# DEPARTMENT OF CITY PLANNING

## RECOMMENDATION REPORT

**Case No.:** VTT-84453-1A  
**CEQA No.:** ENV-2025-5698-SE  
**Incidental Cases:** None  
**Related Cases:** CPC-2025-5697-DB-PR-SPPC-MCUP-VHCA  
**Council No.:** 4 - Raman  
**Plan Area:** Sherman Oaks – Studio City – Toluca Lake – Cahuenga Pass  
**Specific Plan:** Ventura/Cahuenga Boulevard Corridor Studio City  
**Certified NC:**  
**GPLU:** Neighborhood Office Commercial  
**Specific Plan GPLU Zone:** Neighborhood and General Commercial C1.5-1VL-RIO  
**Applicant:** Brett Torino & Eleda Cohen, Studio City Sports Center, LLC  
**Applicant Representative:** Rose Fistrovic, Psomas  
**Appellants:** 1-Barry Johnson, Studio City Residents Association  
2-Studio City for Safe Development Jamie T. Hall, representative  
3-Marianne King

**PROJECT LOCATION:** 12501 - 12665 West Ventura Boulevard

**Figure 4 – Building Section (Sheet A-3.2, MVE + Partners)**

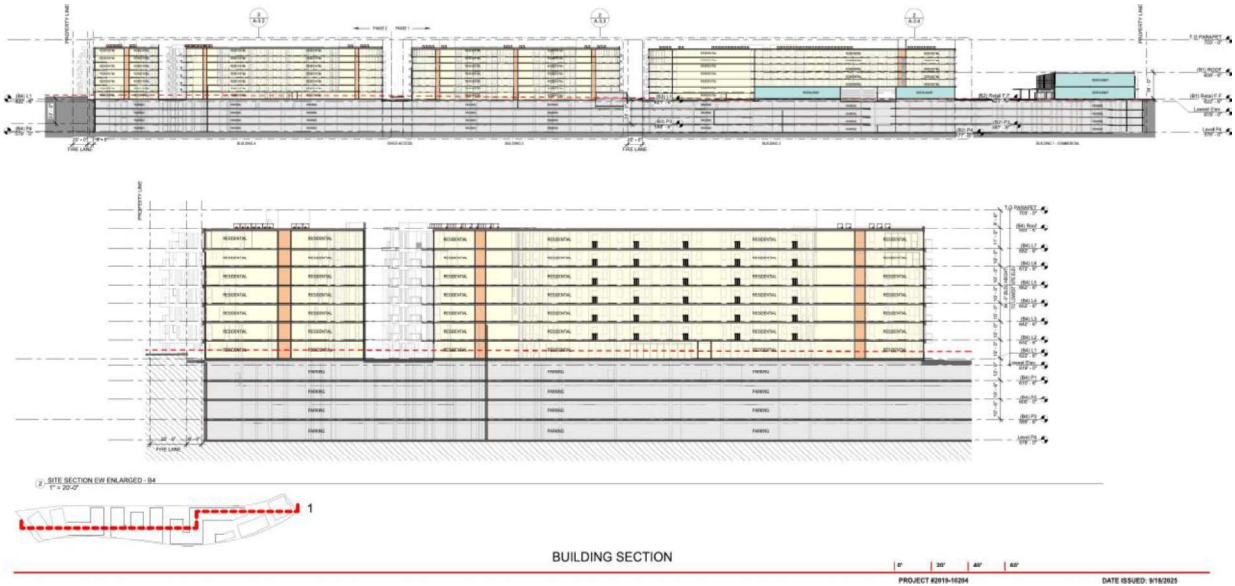
Figure 4 shows Section through Buildings 2, 3, and 4 with seven-story residential construction over the concrete podium subterranean parking garage, top of parapet at approximately 703 ft, and grade plane at approximately 619 ft (vertical distance approximately 84 ft, exceeding the 30 ft threshold for aerial fire apparatus access under 2026 LAFC, Appendix D, Section D105).

- **CD phase item.** Identify the aerial fire apparatus access road and the aerial setup positions for each of Buildings 2, 3, and 4 on the construction document plot plan submitted to the LAFD Hydrants and Access Unit. Provide a minimum 26 ft unobstructed width at the aerial setup location, increased to 28 ft where fire hydrants or aerial apparatus operating positions are located along the access road. Provide a

load-bearing surface rated for fire apparatus loading per Title 14, CCR Section 1273.01. Document the analysis in Appendix C to this report at the CD phase update.
